New location of final assembly and new country of origin of various fuse holder parts.

Product Change Notification					Relocation of production		
owner	creation date	release date	released by	change order no	rev	page	D10-003-914
dislercy	2016-05-04	2016-06-09	bergerra	2009947	A	1 of 2

Label adjustment:

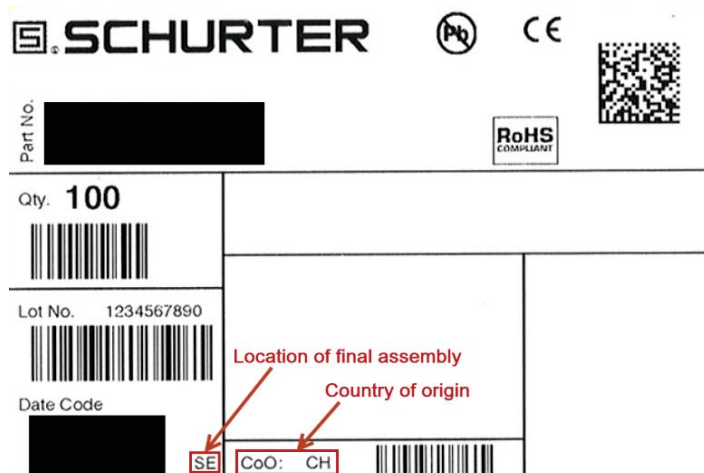
Form	No	There are no form changes
Fit	No	There are dimensional changes
Function	No	This is a non-functional change
Production Site	Yes	Relocation of final assembly from CH to CZ
Product Label	Yes	Adjustment of the label if the location of final assembly and/or the country of origin changes
Customer Action	No	Notification only
